BEFORE THE ENVIRONMENT COURT

Decision No. [2016] NZEnvC 032

DECISION OF THE ENVIRONMENT COURT

PROPOSED AMENDMENTS PPC372

Diagram F08-85(a): Concept Plan – Three Kings

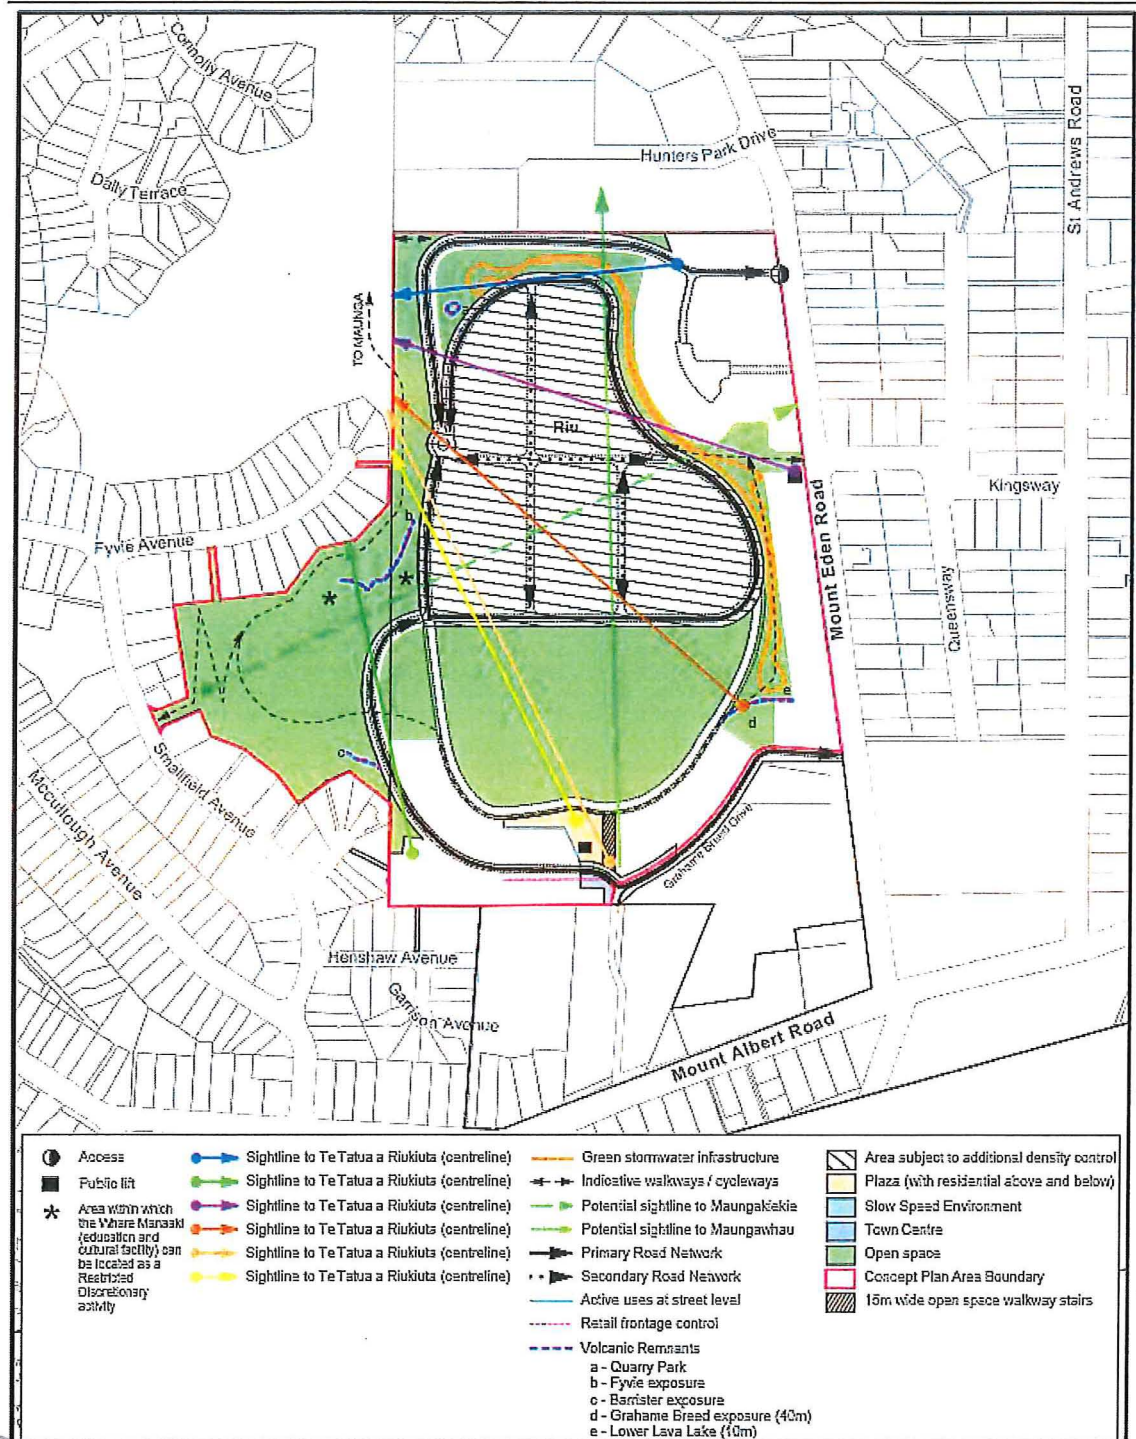
[48] Given that the experts agree that part (f) Rule 21 is an appropriate method to ensure the implementation of public facilities and open space, we consider that concept plan F08-85(a) showing stairs, lifts and walkways as amended by the joint witness statement is an appropriate resolution to this issue. Accordingly we do not require the provision of extra width for a walkable gradient accessway without steps between the sports field and Grahame Breed Drive.

Diagram F08-85(b): Finished Ground Heights (Contour Plan)

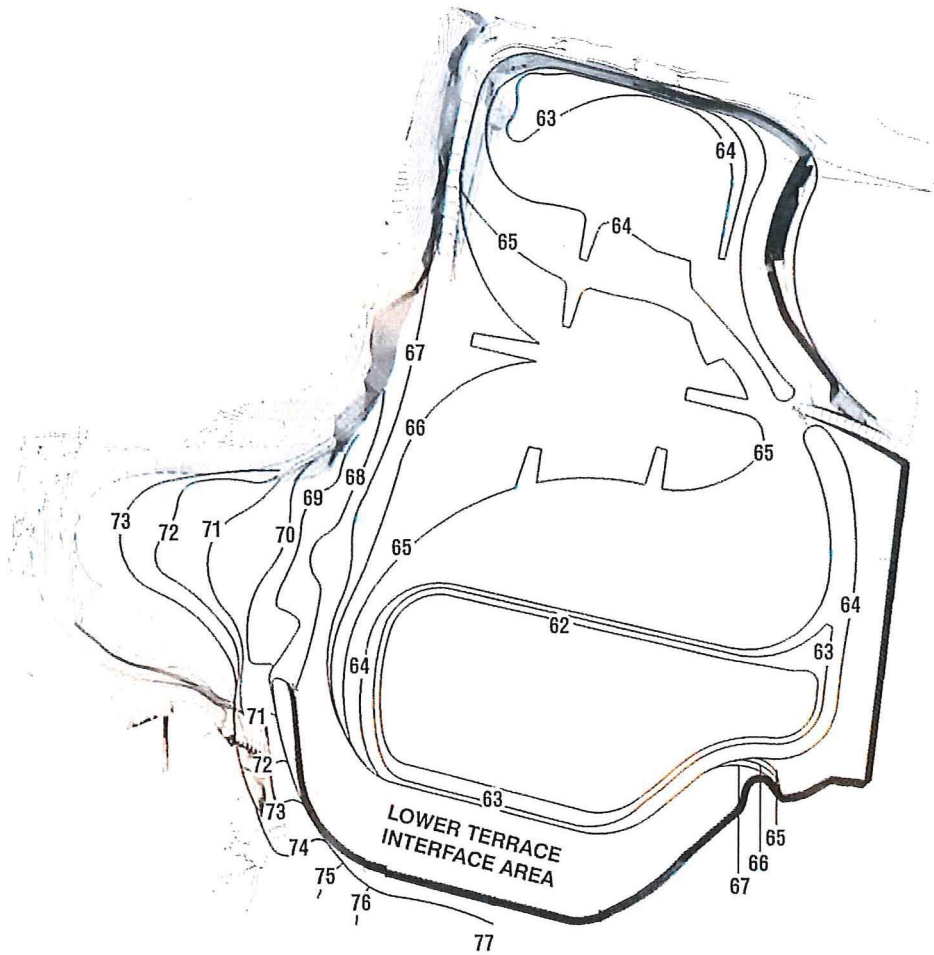
- (a) Height measured above finished ground level (as set out in diagram F08-85(b)). This method is issued for Open Space 2 zoned land and the RIU.
- (b) A maximum reduced level measurement (RL) using the same datum as in diagram F08-85(b). In this case the height is a fixed level irrespective of the ground level beneath. This method has been employed around the quarry edges where steep faces are encountered and thus measurement above ground level is impracticable. This method, therefore, will apply to the cascade apartment typology anticipated by the plan change.

The diagrams should be clearly headed. The diagram F08-85(b) description should be amended to read "Finished Ground Level (Contour Plan) shown as Reduced Levels (RL) referenced from Auckland Datum". This is the intended purpose of the diagram and is the datum to which the levels are referenced. There will, therefore, be no question as to what is expected. Diagram F08-85(c) description should be amended to read "Building Height (Maximum Height)".

Finished ground levels (RL) in the concept plan area shall achieve a minimum height as shown on the Contour Plan Diagram F08-85(b). Ground levels shall be measured in terms of Auckland Datum.

Diagram F08-85(b): Building Height (Maximum Height)

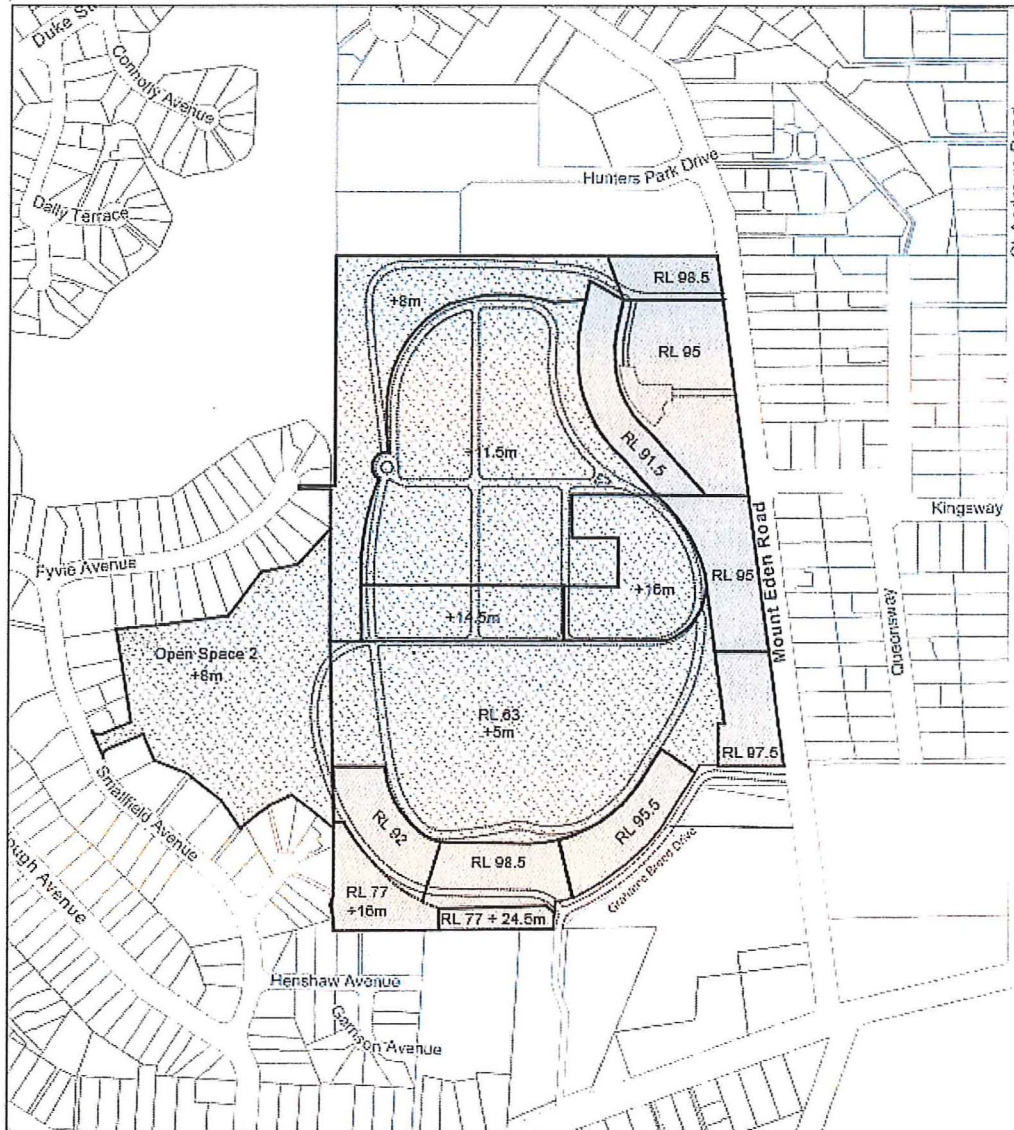
- (a) Diagram F08-85(c) (pertaining to permissible height and as it should now be numbered), references some RL maximums as $RLx + ym$. There is no practical reason to do so as an RL is a fixed figure, so this method of representation has no purpose.
- (b) The reference to diagram F08-85(b) is vital to the determination of permissible height in the Open Space 2 and RIU areas. It sets the expected ground levels from which the permissible height has been derived. Should the developer choose to raise the ground level significantly above the minimum set in the diagram, the permissible building height will also increase.

Diagram F08-85(c) also requires amendment to record the height limits nominated for the land on the south side of Grahame Breed Drive as either the RL as a total figure (eg $RL77 + 16 = RL93$ so the height in the diagram should read 93 and the $RL 77 + 24.5$ should read as 101.0).

Diagram F08-85(e d): Te Tātua a Riukiuta Sightlines

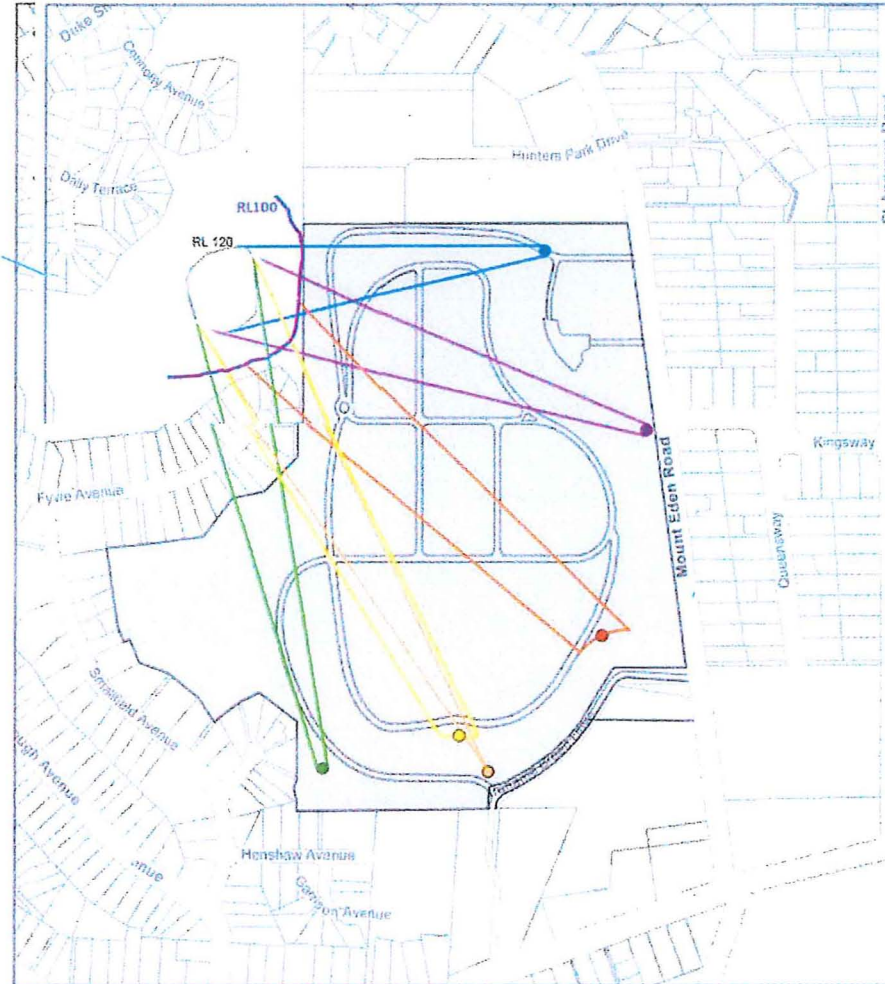
Comment [LA11]: Correction to diagram to insert RL100m contour of cone and the sight line from the dog pound / area "d" on concept plan - this view shaft terminating at this lower contour as required by the Court
